PLANNING, ZONING, & BUILDING DEPARTMENT
PZ&B Staff Combination Memorandum: Architectural Commission and Town Council

SUBJECT: ZON-24-0028 (ARC-24-0032) 272 VIA MARILA

MEETING: NOVEMBER 13, 2024

ZON-24-0028 (ARC-24-0032) 272 VIA MARILA - COMBO. The applicant, Melissa Wight, has filed an application requesting Town Council review and approval of (1) variance to reduce the minimum driveway area in front of the proposed vehicular gate for insufficient vehicular stacking. The Architectural Commission (ARCOM) shall perform design review of the application.

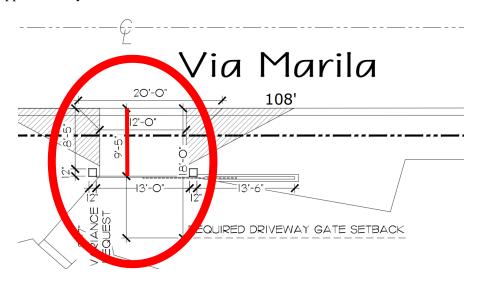
The current proposed decreased the driveway width by 2'-0" (from 14'-0" to 12'-0") and the gate width by 1'-6" (from 14'-6" to 13'-0"). The gate design was also revised to a black wrought iron gate with pickets and finials. This design offers greater transparency than the previous proposals.

The proposed gate requires a variance as the required backup space is not being met, potentially creating an unsafe condition or blockage within the roadway. The applicant has provided 9'-5" of clearance where 18'-0" is needed. It is important to note that Via Marila is a very narrow roadway of only approximately 30'-0' wide.
